761089Orig1s000

OTHER REVIEW(S)

GENERAL HOSPITAL DEVICES BRANCH INTERCENTER CONSULT MEMORANDUM

BLA 761089, Fremanezumab, Prefilled syringe

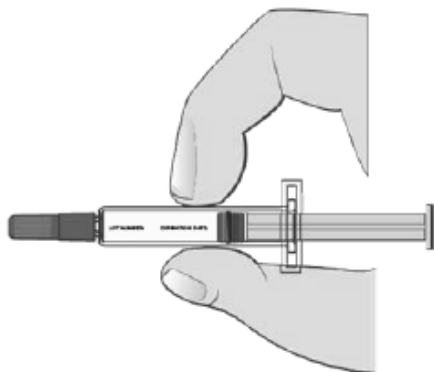
Reviewer Comment: The labeling is acceptable. And includes an Rx statement, manufacturer contact information, lot number, expiration date, single use only.
